# UNITED STATES PATENT AND TRADEMARK OFFICE

10/562,131

<b>Office Action Summary</b>	<b>Application No.</b> 10/562,131	<b>Applicant(s)</b> KAKIUCHI ET AL.	
	<b>Examiner</b> ROCCO ITALIANO	<b>Art Unit</b> 4156

## **DETAILED ACTION**

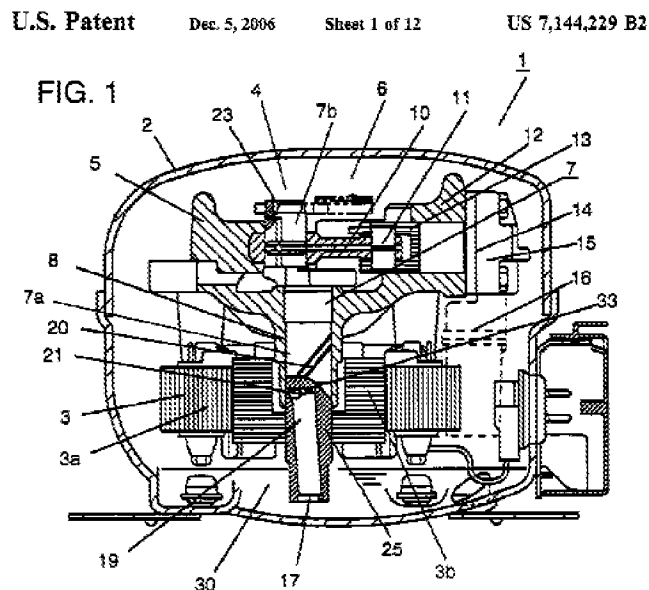
With respect to claim 1, Ishida et al. discloses a hermetically sealed compressor particularly defining similar features as claimed by the applicant (see column 5 line 44 – column 6 line 13 and Fig. 1). Ishida et al. discloses: a hermetic compressor (1) comprising a sealed vessel or body (1) filled with freezer oil (30); an electromotive element (3) including a rotor (3b) and a stator (3a) housed or accommodated within the sealed vessel or body (1); a compressing element or compressing unit (6) which can be visually observed in Fig.1 as being accommodated within an upper region of the sealed vessel and being adapted for to be driven by the electromotive element; the compression element (6) being provided with a crankshaft or shaft (7) which can also be visually observed in Fig. 1 as extending vertically and having the rotor (3b) mounted thereon; Fig. 1 also illustrates a bearing (8) for supporting the shaft (7); a slanting channel or first oil pump (19) provided in the lower portion of the shaft and opening into

the freezer oil (30); a second oil pump comprising a spiral groove (20), provided on the outer periphery of the shaft (7), whereby the second oil pump is provided at the top end or above the first oil pump (19), and an inner peripheral wall surface of the rotor; as seen in Fig.1, the spiral groove (20) is provided along the outer periphery of the main crankshaft (7), whereby a third oil pump, provided above the second oil pump, is formed by the spiral groove (20) provided on the outer periphery of the shaft (7) and an inner peripheral surface of the bearing (8).

In regards to claim 2, it can be visually observed from Fig. 1 according to Ishida that the spiral groove (20) of the second and third oil pump is formed continuously.

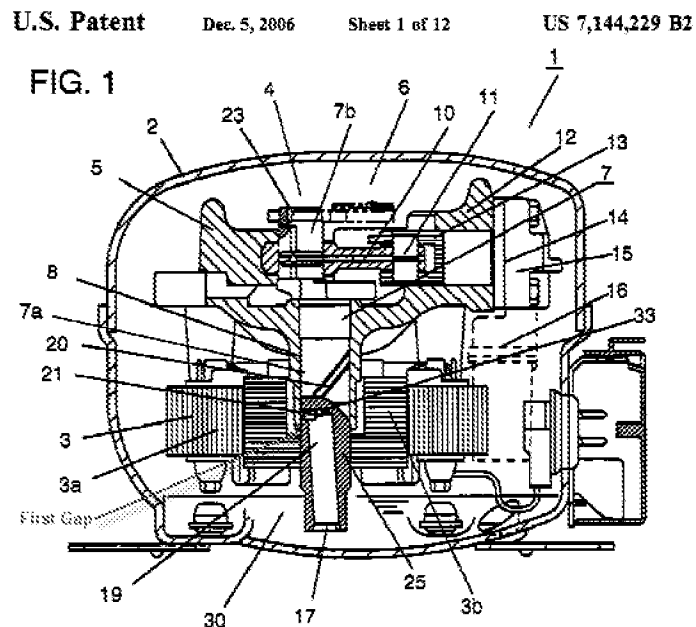
In regards to claim 3, Fig.1 according to Ishida illustrates the spiral groove (20) of the second and third oil pump as being provided on the outer periphery of shaft (7). It may be observed from Fig. 1 that the shaft on which the spiral groove (20) is provided is in communication with a first gap formed between the rotor (3b) and bearing (8)

therefore allowing for open communication between first gap and spiral groove (20) (see Fig. 1 labeled by the examiner for clarity).

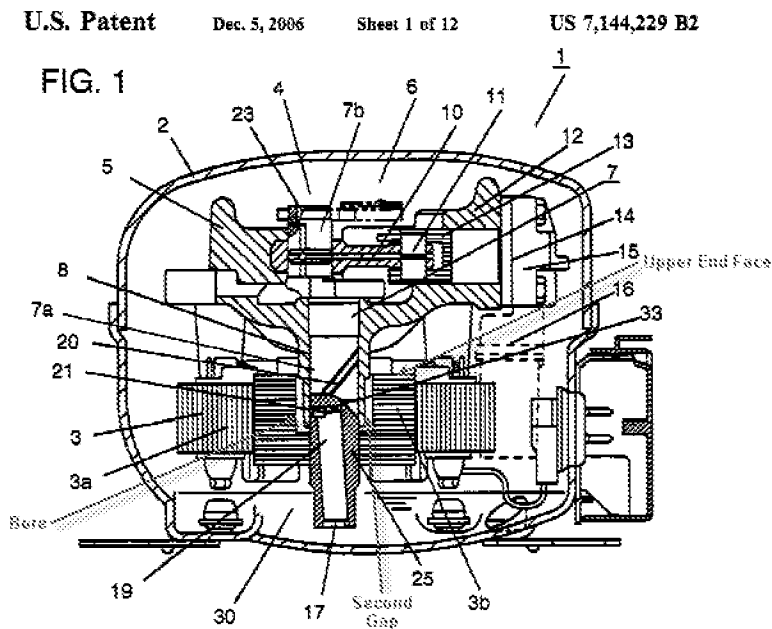
With respect to claim 5, Ishida discloses in Fig. 1 a rotor with an upper end face formed with a bore for receiving the bearing (8) whereby a second gap is formed between an inner peripheral surface of the bore and an outer peripheral surface of the bearing (see Fig. 1 label by the examiner for clarity).

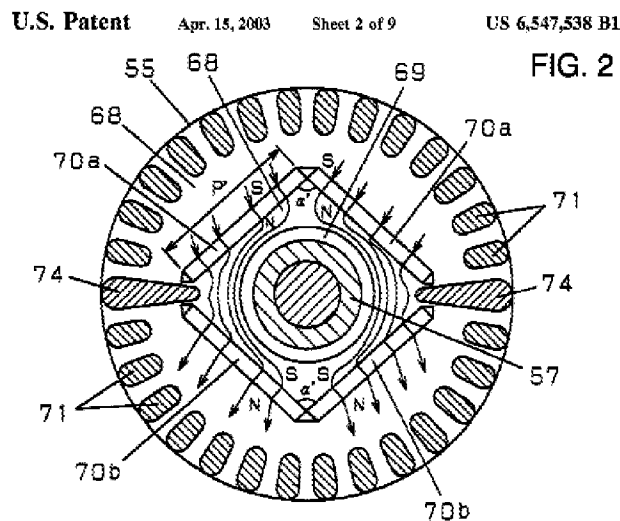
With respect to claim 10, Ishida et al. discloses a hermetically sealed compressor particularly defining similar features as claimed by the applicant (see column 5 line 44 – column 6 line 13 and Fig. 1). Ishida et al. discloses: hermetic compressor (1) comprising a sealed vessel or body (1) filled with freezer oil (3); an electromotive element (3) including a rotor (3b) and a stator (3a) housed or accommodated within the sealed vessel or body (1); a compressing element or compressing unit (6) which can be

visually observed in Fig.1 as being accommodated within an upper region of the sealed vessel and being adapted for to be driven by the electromotive element; the compression element (6) being provided with a crankshaft or shaft (7) and an eccentric shaft portion (7b) which both can be visually observed in Fig. 1 as extending vertically and having the rotor (3b) mounted thereon; Fig. 1 also illustrates a bearing (8) for supporting the shaft (7); a slanting channel or first oil pump (19) provided in the lower portion of the shaft and opening into the freezer oil (30); a second oil pump comprising a spiral groove (20), provided on the outer periphery of the shaft (7), whereby the second oil pump is provided at the top end or above the first oil pump (19), and an inner peripheral wall surface of the rotor; as seen in Fig.1, the spiral groove (20) is provided along the outer periphery of the main crankshaft (7), whereby a third oil pump, provided above the second oil pump, is formed by the spiral groove (20) provided on the outer periphery of the shaft (7) and an inner peripheral surface of the bearing (8).

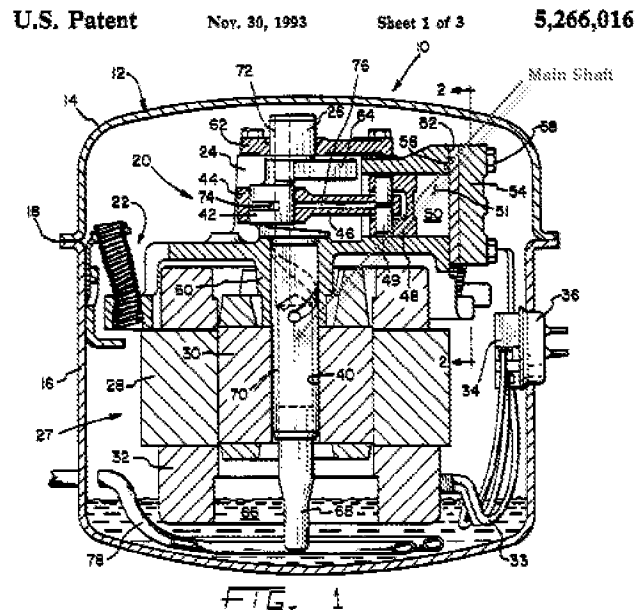
In regards to claim 11, Kandpal teaches of a hermetically sealed compressor wherein it may be visually observed in Fig. 1 that the element (60), analogous to the main bearing as designated by the applicant, is arranged in a comparable manner in which it (60) does not intersect a plane containing one end of the rotor core (30) adjacent the compressing element (20) and lying generally perpendicular to a longitudinal axis of the main shaft (labeled by examiner) (see Fig. 1).

With respect to claim 12, Fig. 1 according to Kandpal, also provided an illustrated teaching in which auxiliary shaft portion (26) provided coaxially of the main shaft portion (labeled by the examiner) with the eccentric shaft portion (42) intervening between the main shaft portion (labeled by the examiner) and the auxiliary shaft portion (26), and an auxiliary bearing (62) for supporting the auxiliary shaft portion (26) (see Fig. 1).
